## ADAMS NORTH TECHNOLOGY CENTRE JSP19-05

Consideration at the request of Northern Equities Group for Preliminary Site Plan and Storm Water Management plan approval. The subject property contains 6.7 acres and is located in Section 1, on the north side of MacKenzie Drive east of the planned extension of Cabot Drive, part of the Haggerty Corridor Corporate Park. The vacant parcel is zoned OST, Office Service Technology. The applicant is proposing to construct a one-story building with office space and laboratory space totaling 56,429 square feet. This project was approved in 2014 and returned to Planning Commission for approval in 2017, but was never built.

Approve/Deny the Preliminary Site Plan and Storm Water Management Plan.

# PLAN REVIEW CENTER REPORT

ORIGINAL ISSUE DATE: JANUARY 22, 2019  
 PEA JOB NO. 2019-016  
 SCALE: 1" = 40'  
 DRAWING NUMBER: C-7.0

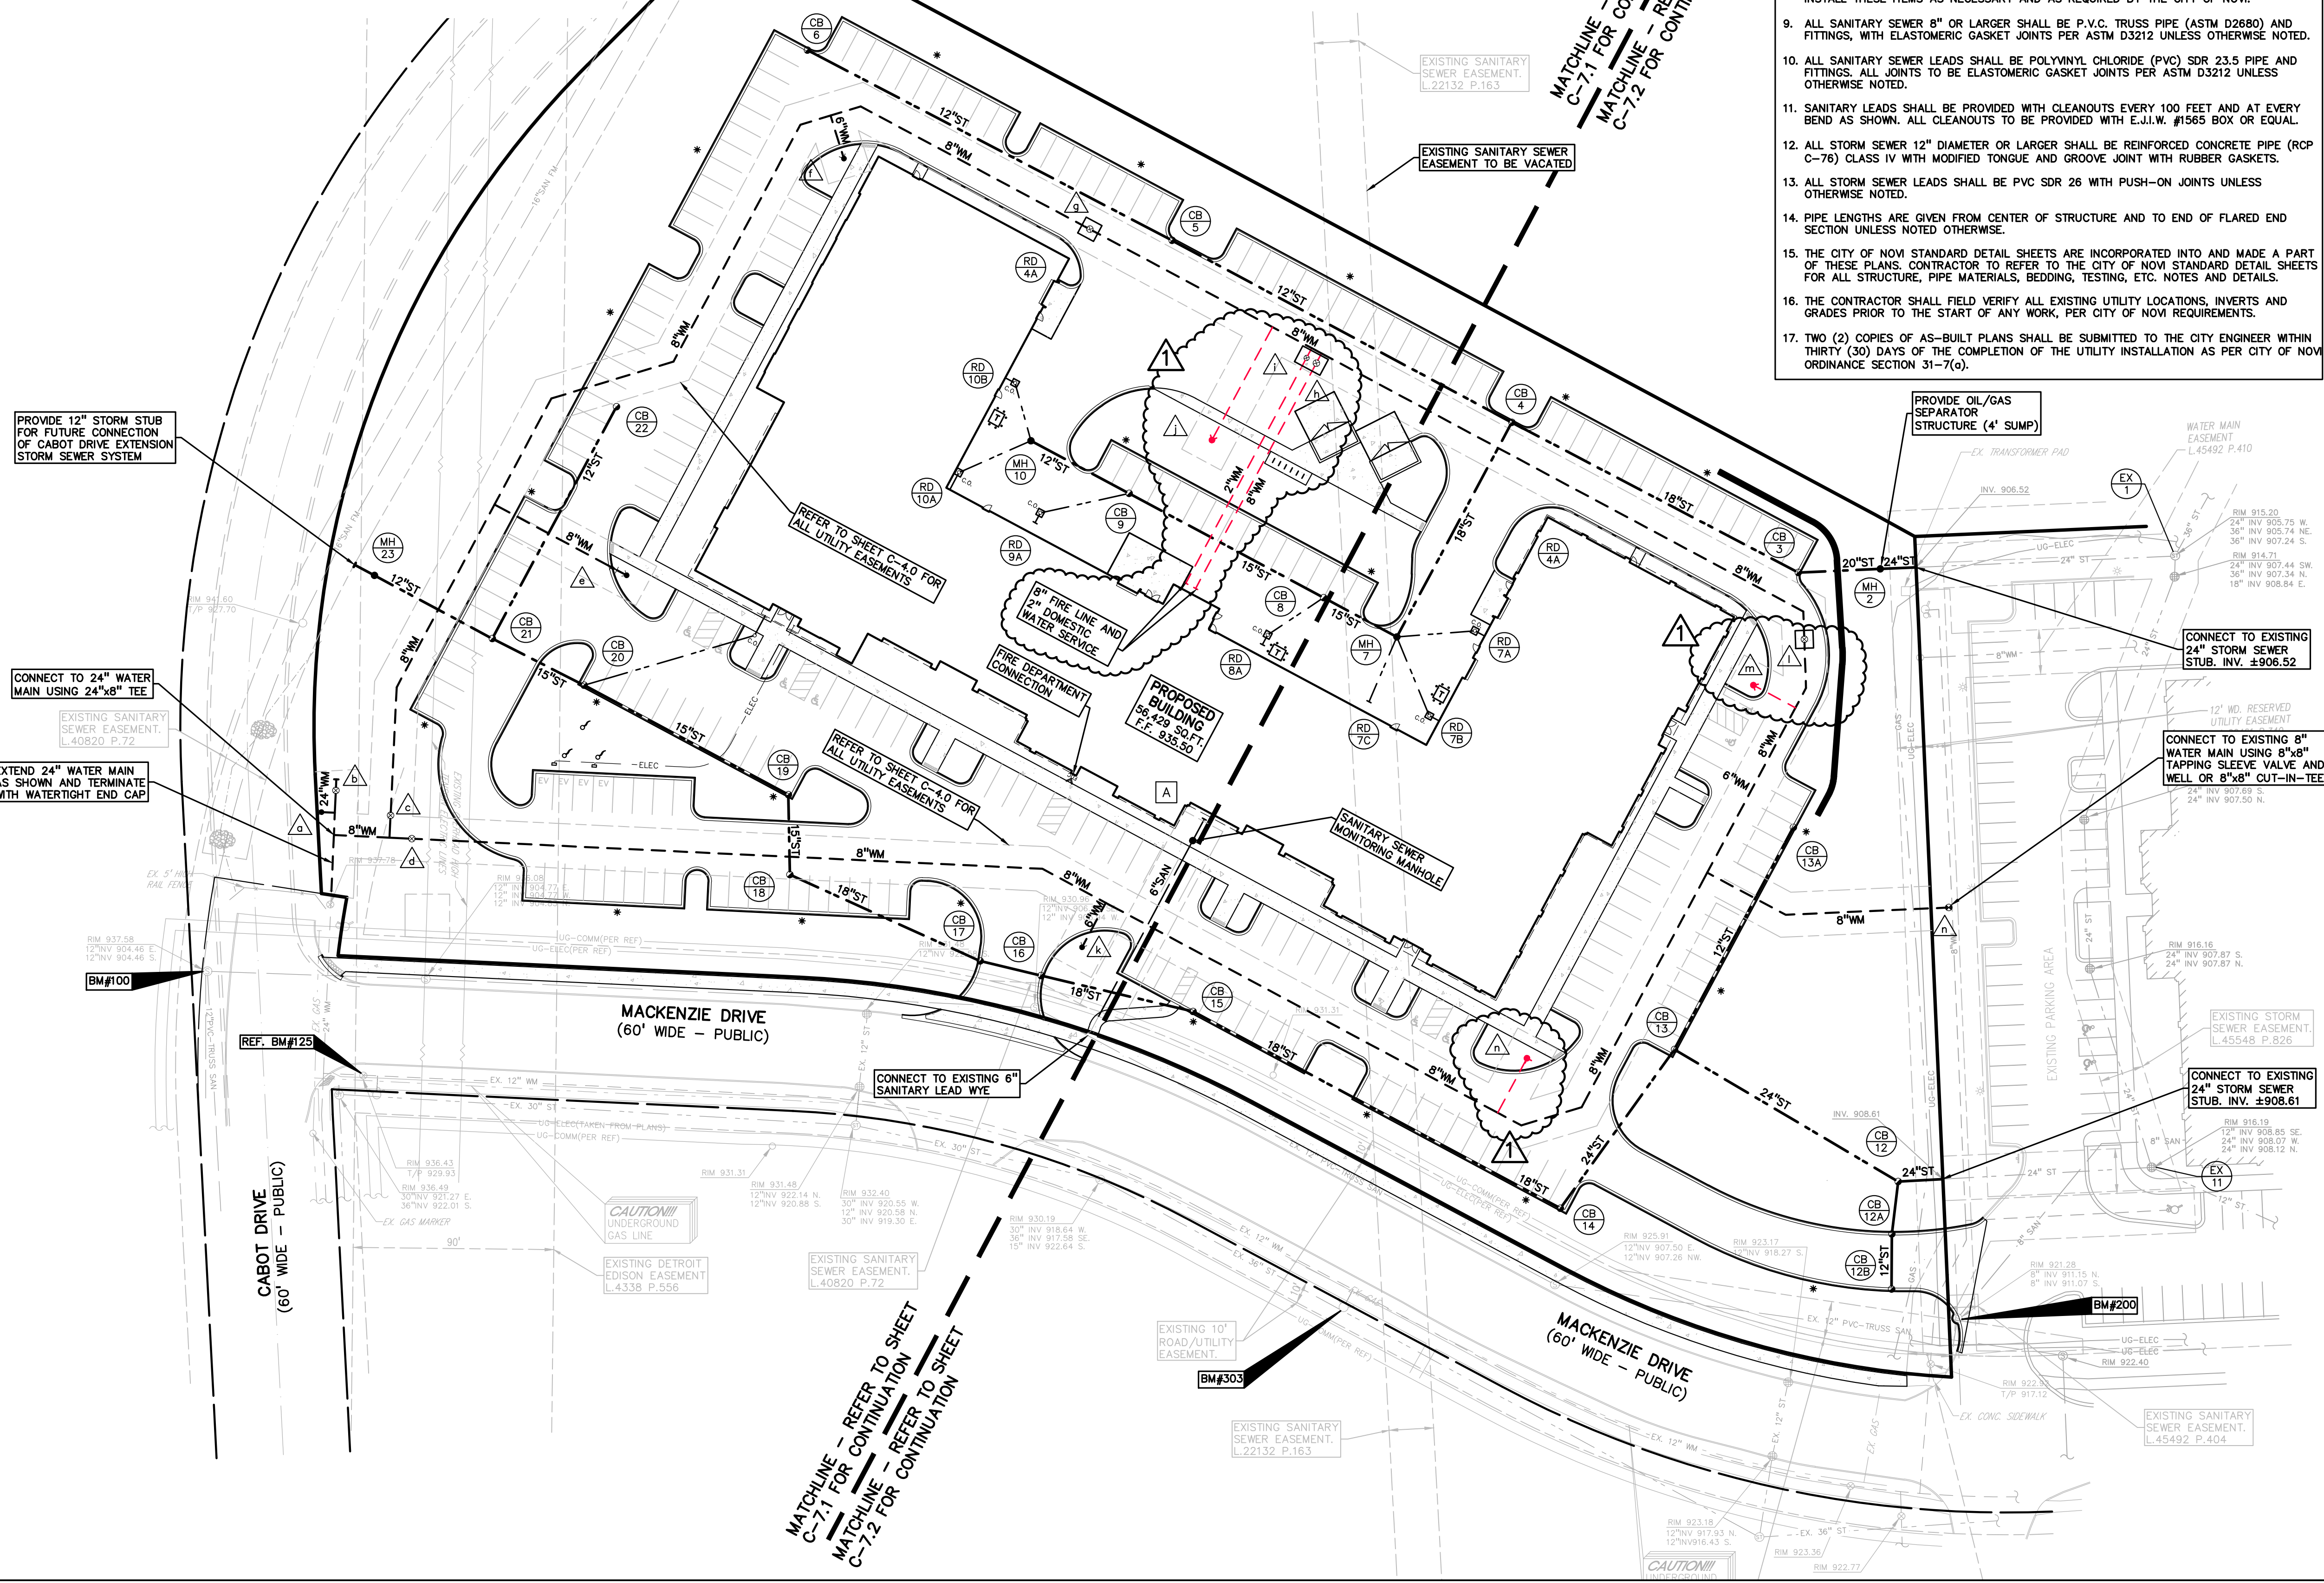
6. Change note on sheet C-7.0 to state, "All hydrants to be a minimum of **7 feet** from back of curb". This is according to section 11-68(f) of the City's Code of Ordinances.
7. Provide separate domestic lead and fire service lead from the water main for building with a unique shut-off valve for each. Shut-off valves to be placed within water main easement.
8. Hydrant leads in excess of 25 feet to be minimum 8-inch diameter.
9. Three (3) sealed sets of revised utility plans along with the MDEQ permit application (06/12 rev.) for water main construction and the Streamlined Water Main Permit Checklist should be submitted to the Engineering Division for review, assuming no further design changes are anticipated. Utility plan sets shall include only the cover sheet, any applicable utility sheets and the standard detail sheets.

1. Comment noted.
2. After discussion with the Fire Marshal, the proposed domestic service and fire service leads will be separated from the water main loop to the building, each with individual shut-off valves. A revised sheet C-7.0 was emailed to the Fire Marshal to document our intent. These changes will be incorporated into the Stamping Set submittal.

3. After discussion with the Fire Marshal, the hydrant spacing will be revised to provide 300' spacing along the main. A revised sheet C-7.0 was emailed to the Fire Marshal to document our intent. These changes will be incorporated into the Stamping Set submittal.
